RE: Echo Well #5 Variance

**REQUEST FOR WRITTEN APPROVAL TO USE CONSTRUCTION METHODS NOT
INCLUDED IN THE RULES AND REGULATIONS PRESCRIBING GENERAL STANDARDS
FOR THE CONSTRUCTION AND MAINTENANCE OF WELLS IN OREGON**

Echo Well #5

Proposed Final Construction

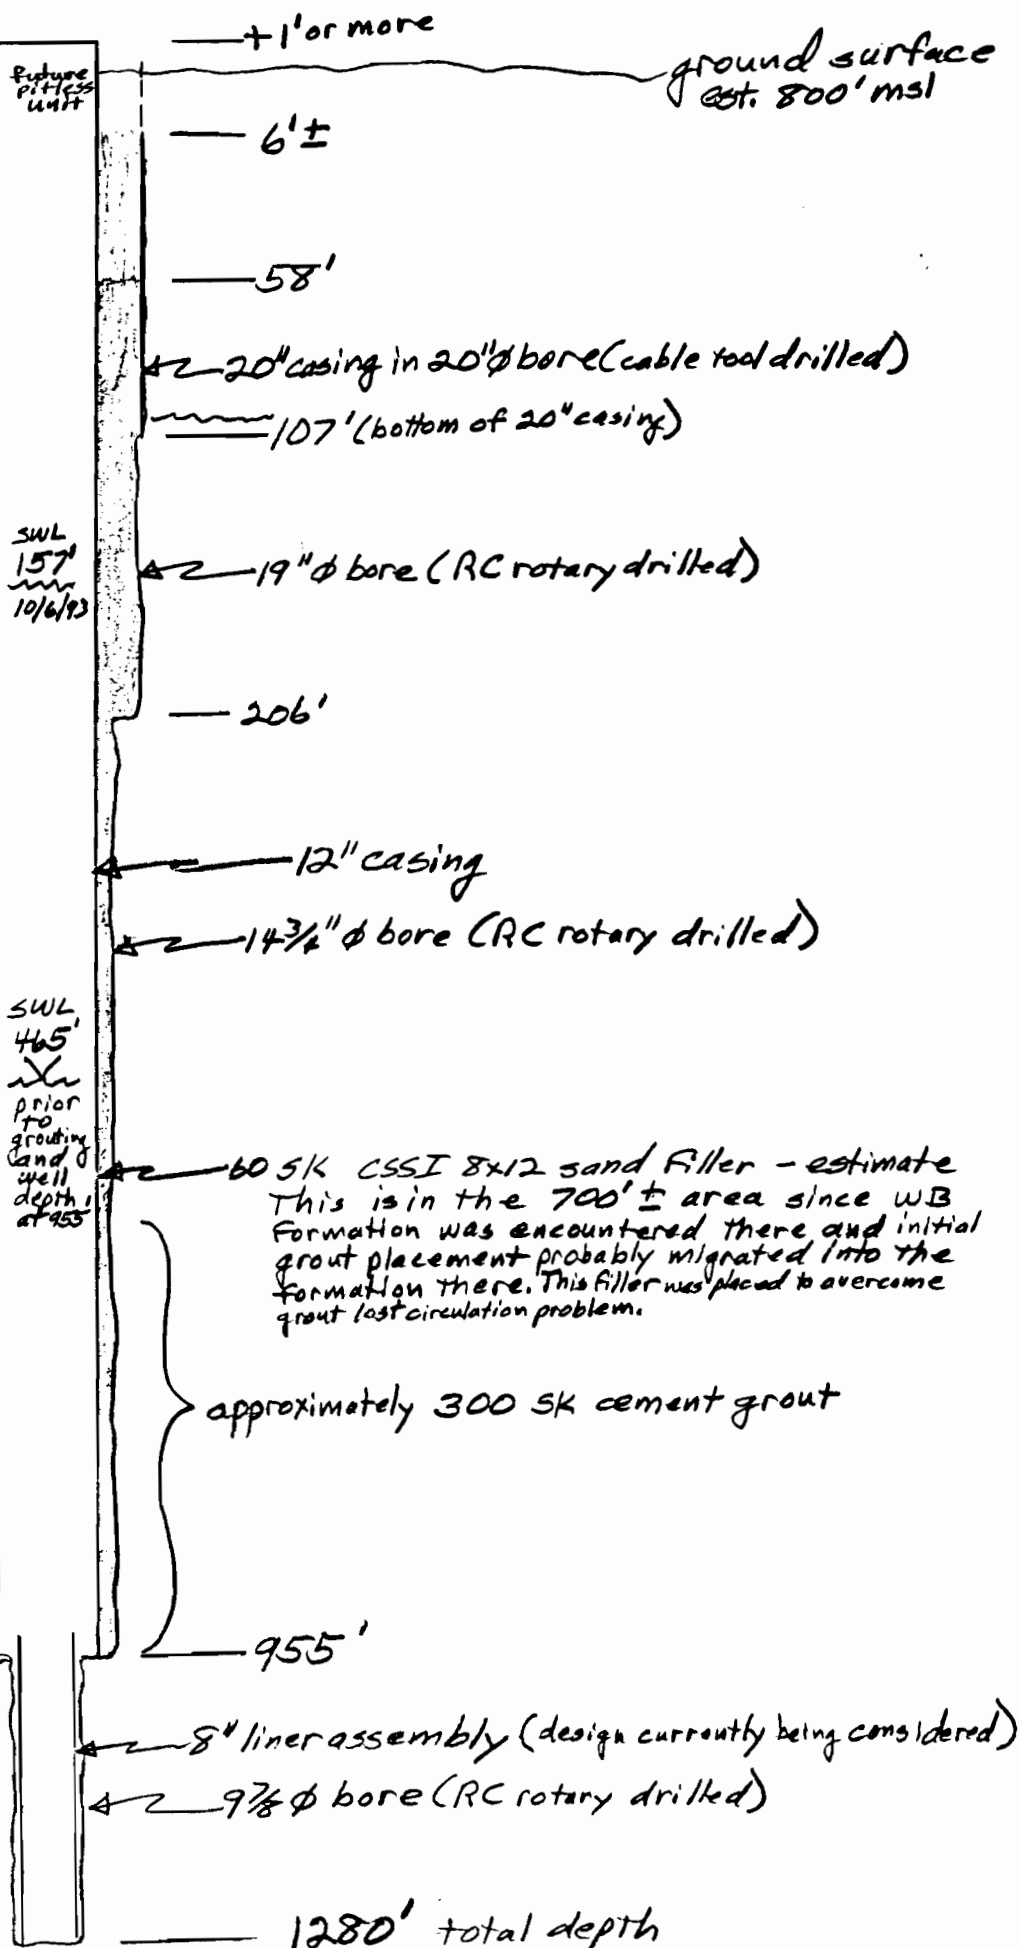
The current construction of the well is described in your submittal. The 20 inch temporary surface casing became accidentally grouted in the hole to a depth of 107 feet. Annular seal exists outside the 12 inch casing from 107 to 955 feet, and between the 12 inch and 20 inch casing from 6 feet to 107 feet. The upper 6 feet will be sealed with bentonite after placement of a pitless unit.

You are proposing to leave the 20 inch surface casing in place considering the existing annular seal and the lack of water within the upper 107 feet. According to the rough log information submitted by you, it does not appear that the lack of a seal outside the 20 inch would allow commingling of waters between two unlike water producing zones. The annular seal below 107 feet appears to effectively protect the water producing zones within the basalts. Therefore your request is approved. Please note, however, that if it should be determined at some future date that the well is offering an avenue for pollution, you will be required to repair the well.

proposed removal of 20" casing & no seal for future or present installation of a pit-less unit.
proposed additional grout placement,

105' alluvial
basalt

200 SK cement grout
(first 100 SK of this did not come above the 206' bore-hole size change)
